BEFORE THE PUBLIC UTILITY COMMISSION
OF OREGON

Docket No. LC 85

In the Matter of PACIFICORP, dba PACIFIC POWER, 2025 Integrated Resource Plan.	Opening Comments of NW Energy Coalition

Figure A.1 – PacifiCorp System Load Forecast Change, at Generation, pre-DSM

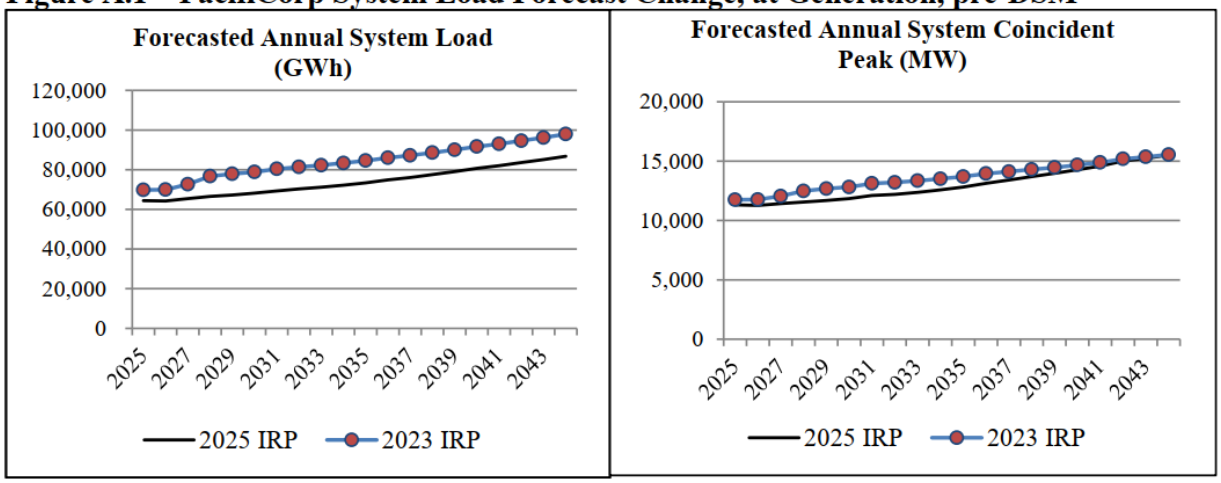
The IRP further states, "The compound annual load growth rate for the 10-year period (2025 through 2034) is 1.28 percent. Relative to the load forecast prepared for the 2023 IRP, PacifiCorp's 2034 forecast load requirement decreased in all states other than Washington **resulting in PacifiCorp system load requirement to decline 13.35 percent in 2034.**" Ibid., emphasis added.

Likewise, reflecting updates to the IRP demand forecast and continuing the arbitrary exclusion of potential new large loads, the CEP states: "PacifiCorp's current CEP load forecast reflects a modest growth rate in Oregon retail sales over the next 10-year period (a compounded annual growth rate of 0.07 percent). **This is a material difference from the 2023 CEP, which forecasted a 4.39 percent 10-year compounded annual growth rate."** CEP at 102, emphasis added.

Yet the CEP continues: "These forecasts can differ dramatically each CEP cycle based on the timing and siting of data center load. For example, the 2025 IRP includes a high data center load forecast scenario, which indicates an approximate 7.5 GW of additional system resources that could be needed to meet increased demand by 2045. High data center load growth presents material compliance issues for HB 2021 purposes."

We agree that volatility in the near term for major data center and other industrial load growth is one of the primary focuses of the planning process for the Company, the Commission and stakeholders alike. But PacifiCorp is not given leeway to shield this pivotal part of the planning environment from full scrutiny. Removal of prospective major new load undermines the IRP's role as the main direction-setting mechanism for investment in new resources for the benefit of PacifiCorp customers.

The clear intention of Commission policy is not to allow utilities to pick and choose which future load additions to include in the IRP. The one clear exception is for direct access. Under IRP Guideline 9, "an electric utility's load-resource balance should exclude customer loads that are effectively committed to service by an alternative electricity supplier." However, this exception is clearly limited to additional loads with a resource plan that has been approved by the Commission under its standard review processes.

In all previous IRPs, PacifiCorp made no distinction between different kinds of new loads forecasted to be added to service requirements. The modeling change in the 2025 IRP is predicated on PacifiCorp's separation of an undefined set of prospective new retail loads which do not by definition have executed agreements consistent with the Commission's direct access policy.

As the IRP discussion shows, this change in modeling input assumptions by the Company dramatically shifts the starting point for the demand forecast and consequently all other aspects of the modeling, including the characteristics of the resource scenarios evaluated and the final proposed preferred resource portfolio.

in Commission-approved direct access agreements, must be included in the IRP and CEP. The Company cannot substitute its self-defined "expected to provide or pay" standard as the baseline for the IRP and CEP.
